1011 Bay Rd

SEPTIC "AS-BUILT" CONDITIONS
 PREPARED FOR
VALLEY BUILDERS, LLC
 1011 BAY ROAD
 AMHERST, MA

PLAN OF PROPOSED SEWAGE DISPOSAL SYSTEM
PREPARED FOR
VALLEY BUILDERS, LLC
#1011 BAY ROAD
AMHERST, MA

RE: Review of Septic Plan for 1011 Bay Rd., Amherst

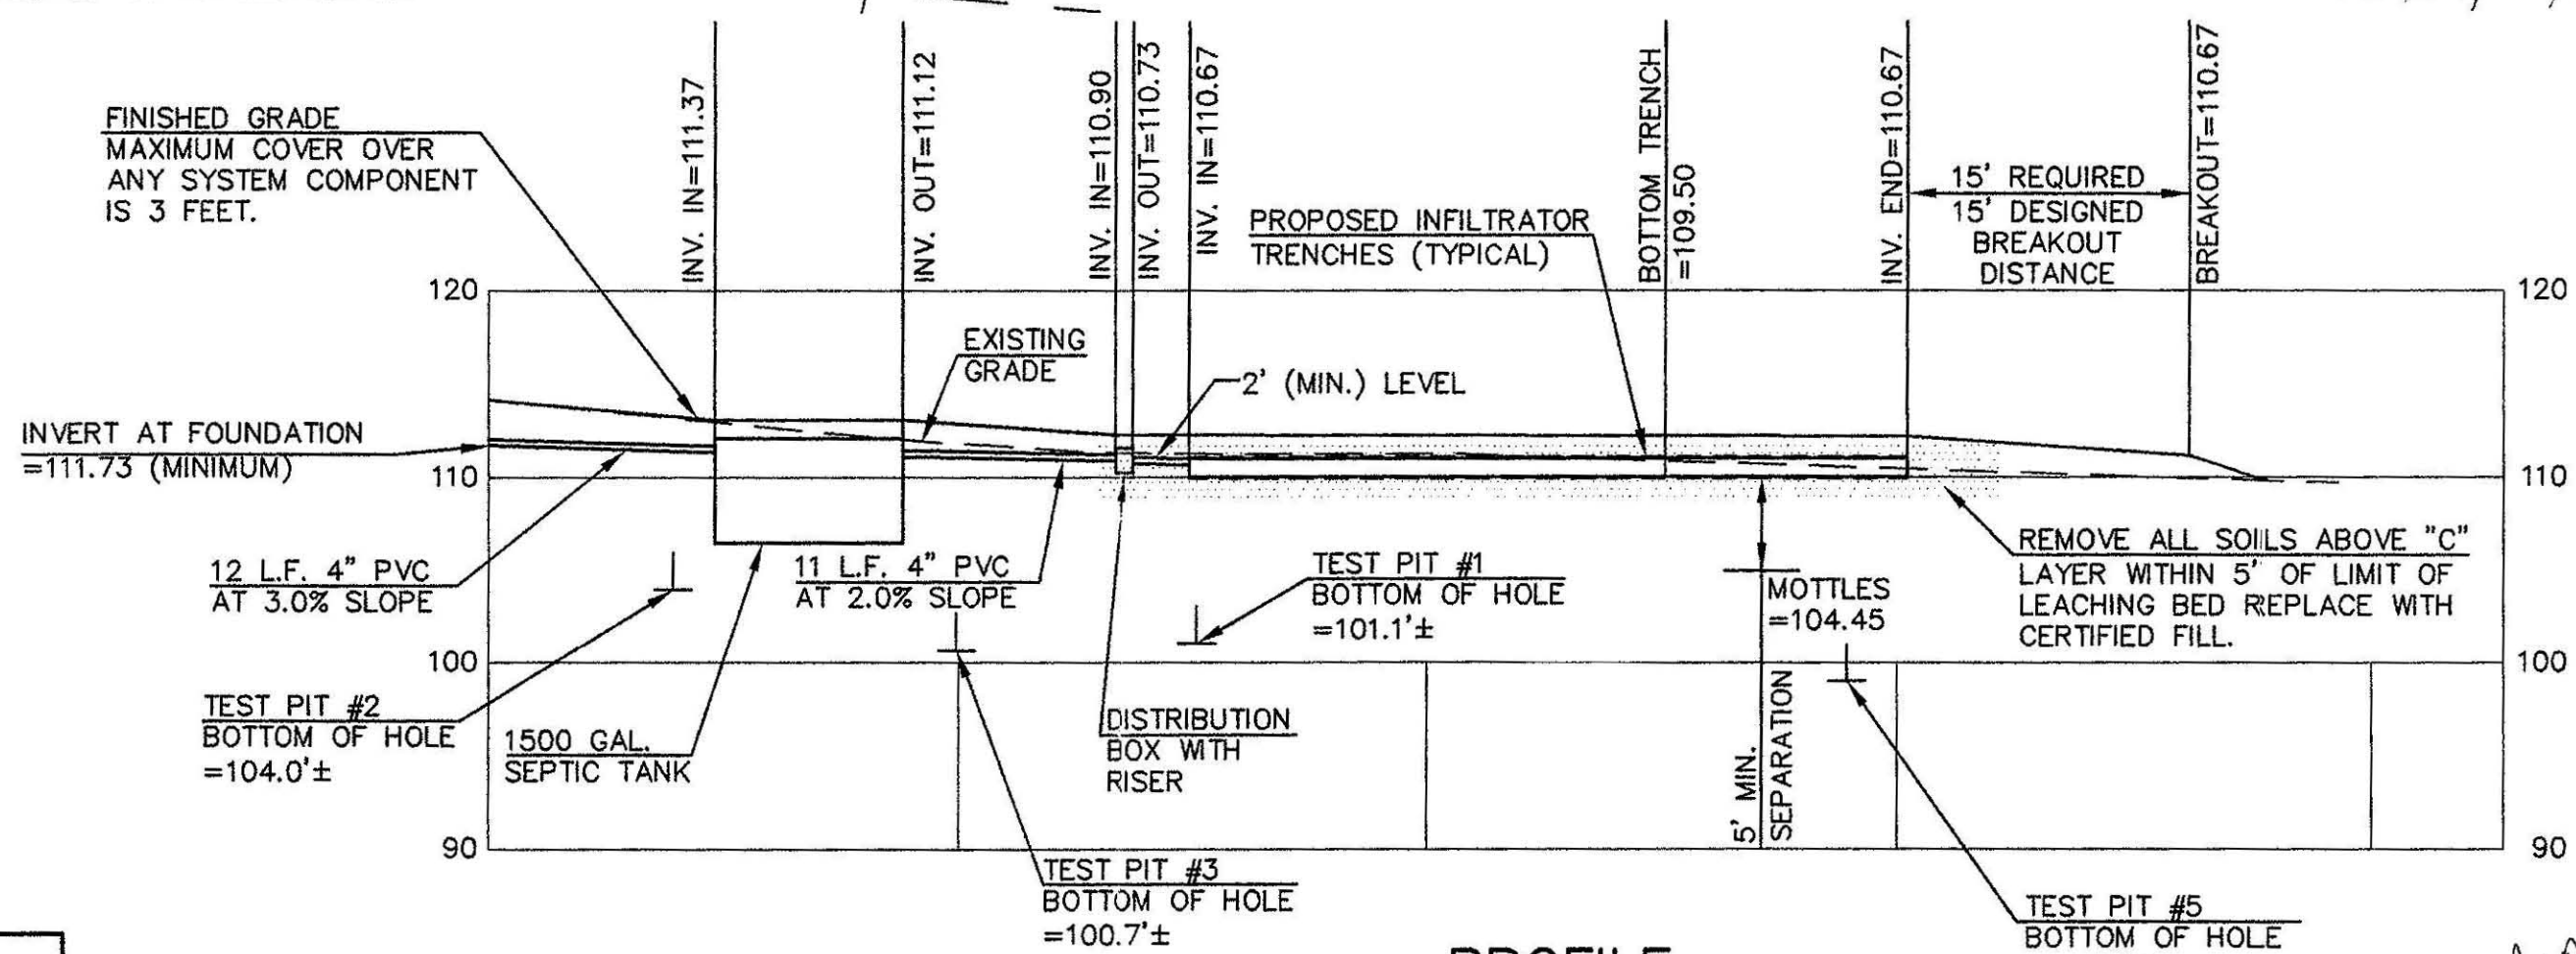
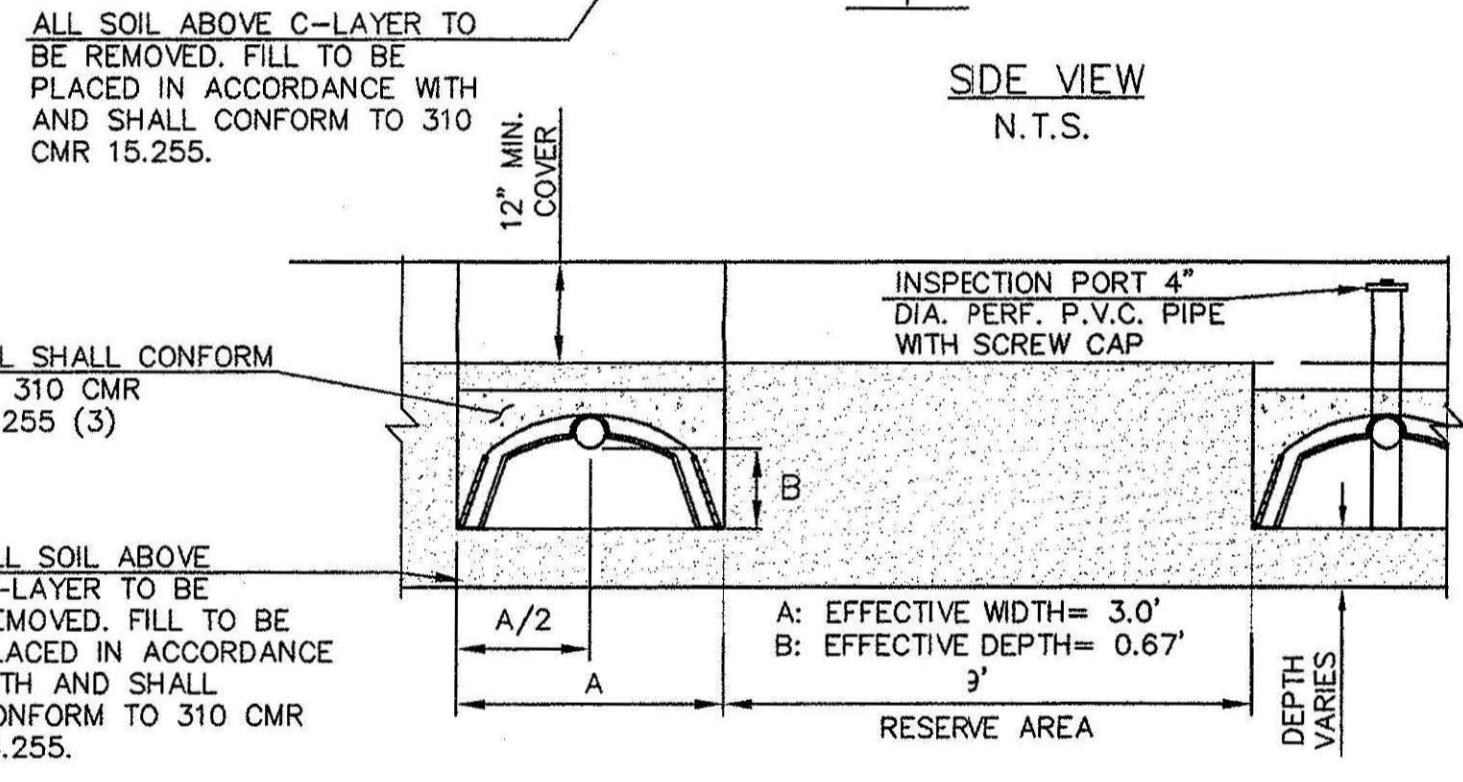
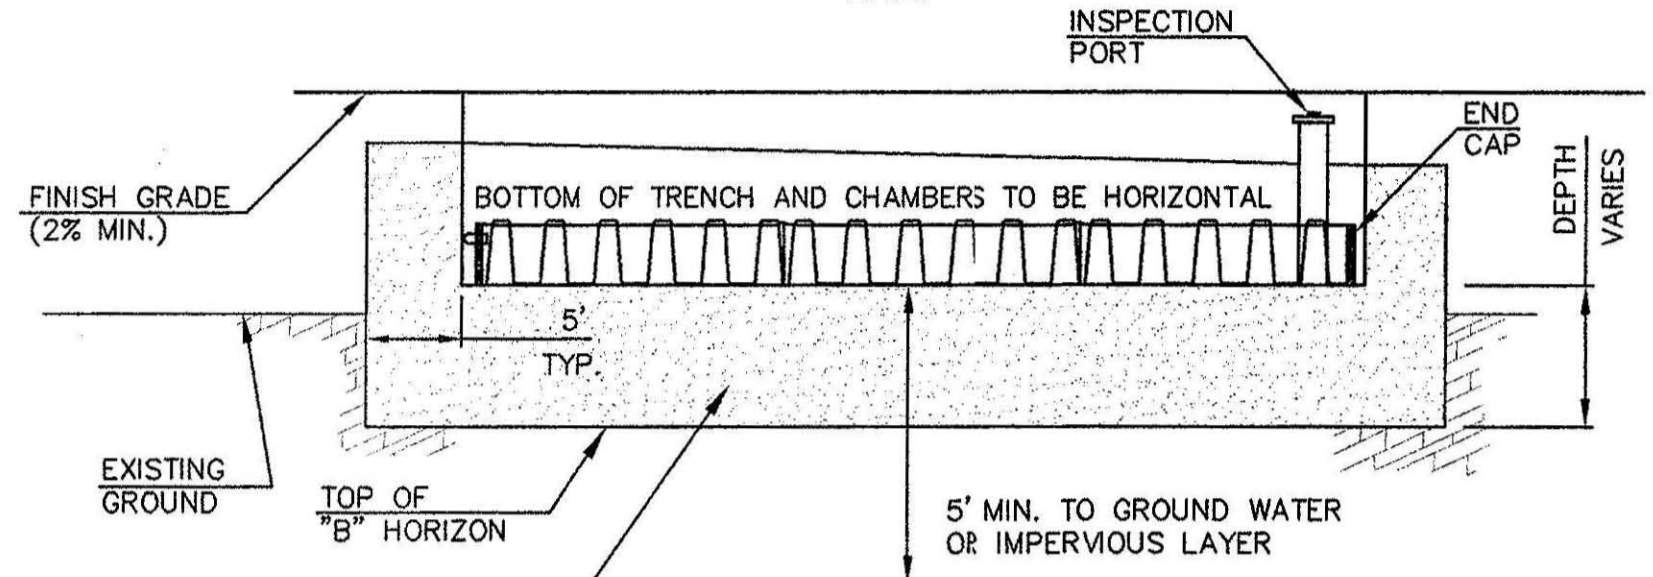
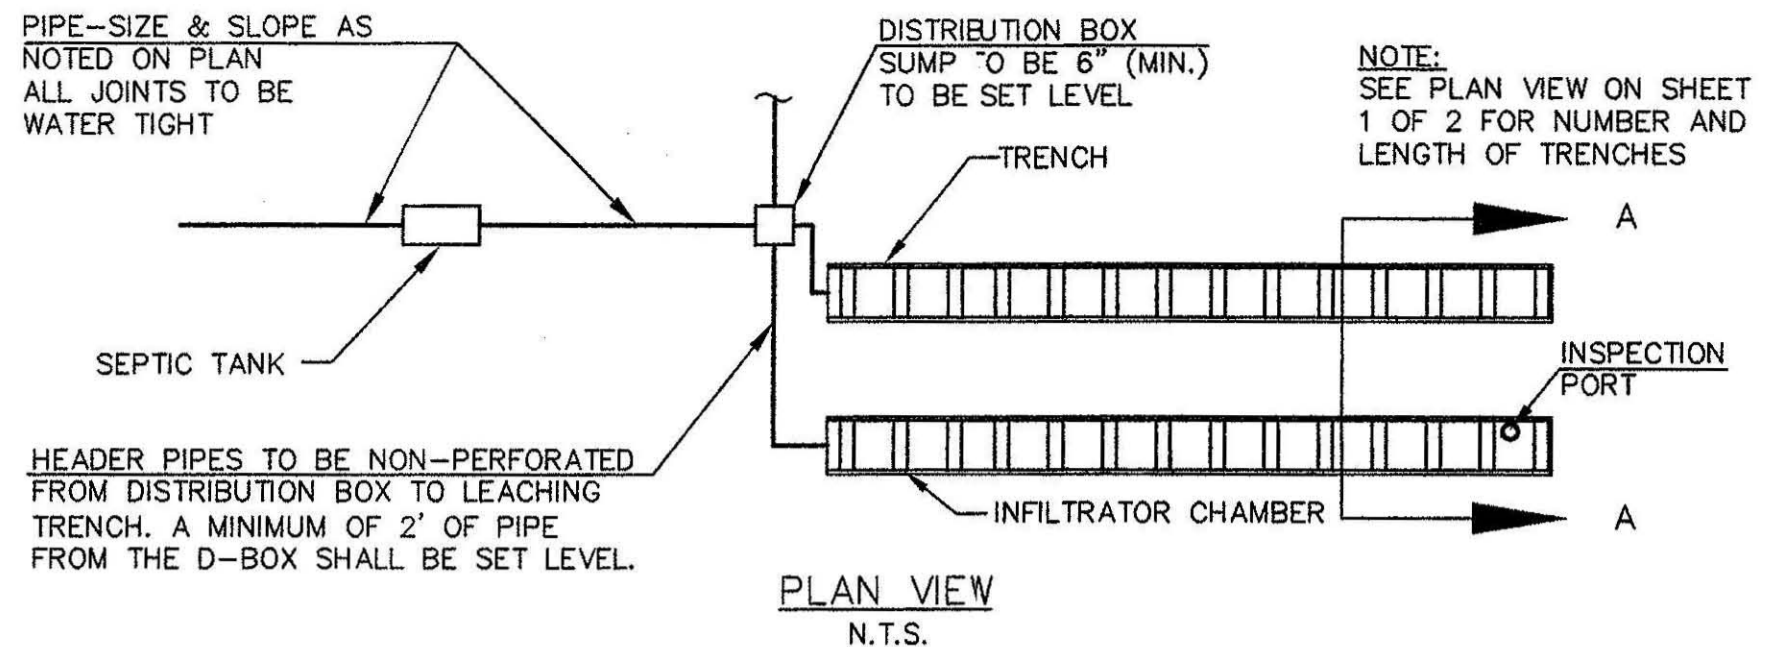
A review of the septic design plan for property at 1011 Bay Rd., Amherst revealed the following deficiencies:

- The plan showed only one deep hole/test pit at the site of the proposed sewage disposal system, when a minimum of two are required by code.
- The Construction notes on the plan called for the excavation of all soils above the "B" horizon, and called for the construction of the disposal system in "Title 5 sand" placed on top of the "B" horizon. The "B" horizon was not perc tested but was listed as being a Fine Sandy Loam which has a smaller sewage application rate than the "C" horizon which was perc tested.

I have spoken with the plan designer (Donald Frydryk) and suggested the following actions:

- Have another test pit excavated at the site of the proposed disposal system.
- Revise the plan to call for the excavation of the "B" horizon or the leaching system design size must be revised and based on the slower application rate that is listed in the code for Fine Sandy Loam.

Mr. Frydryk agreed to inform the property owner that another deep hole/test pit was required and to revise the plan to call for the removal of the "B" horizon.
